## Dharma Cloud Foundation

Re.: Federal Consistency Review for the replacement of the Ten Mile Bridge,  
Mendocino County, CC-74-05

Item 20 c. **CC-74-05**

**Figure 1** Rates of related accidents by roadway width from Models I and II

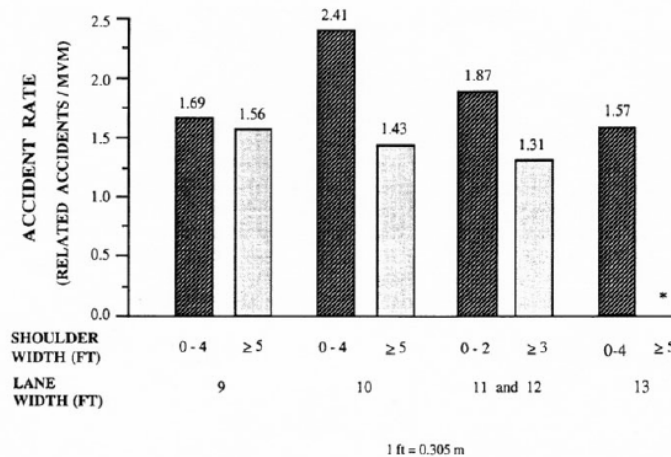
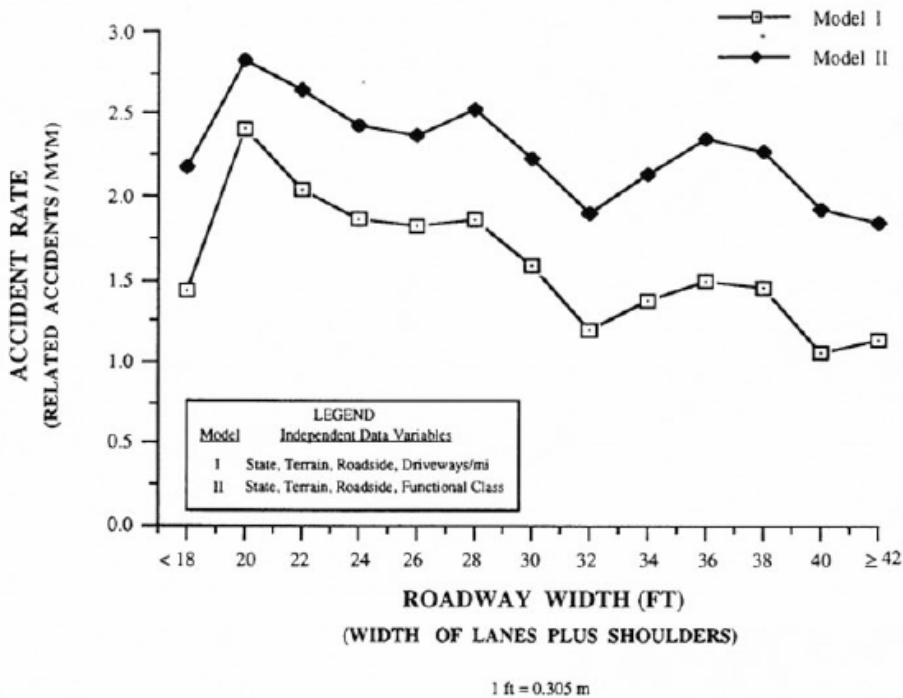
**Widening the shoulders from 1' to 4' would provide a significant additional safety margin, but increasing from 4' to 8' would not significantly reduce accident rates.** The figure below is from a study of accidents on low-volume roads, such as Highway 1 at Ten Mile River<sup>1</sup>. It shows that moving from a 1' shoulder to greater than 3' reduces the expected accident rate by 30%.

Figure 1 of this study shows that moving from 3-4' to 8' shoulders (32' to 40' total roadway width) does not result in a statistically significant reduction in accident rates.<sup>2</sup>

**To summarize, the best available evidence shows that increasing shoulder width from 4' to 8' would have no significant safety benefit.**

### **Why a two-rail system with the ST-10?**

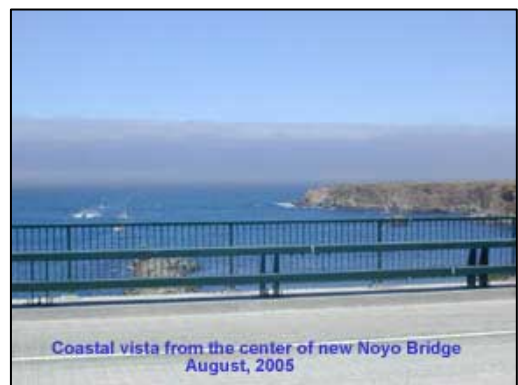
1. National safety standards (the "AASHTO" standards) subscribed to by California say that pedestrians on bridges shall be protected from vehicles when the highway is designed for high speeds (50 MPH or greater). This protection requires a traffic barrier on the traffic side of the sidewalk.

Because the bridge will be occupied by pedestrians, the proposed use of a combination vehicle-pedestrian-bicycle rail, the ST-20, on the Ten Mile Bridge is contrary to AASHTO standards. The AASHTO standards limit use of a combination vehicle-pedestrian rail placed on the outer edge of a bridge, "to roads designated for 45 MPH or less."<sup>3</sup> Another ASHTO document says, "For speeds of 50 MPH or greater, pedestrians should be protected by a separation traffic barrier."<sup>4</sup>

2. The AASHTO standards for pedestrian protection can be met by using the two-rail system so successfully employed on the new Noyo Bridge. The inner rail is an ST-10, which has a low height and good visual transparency.
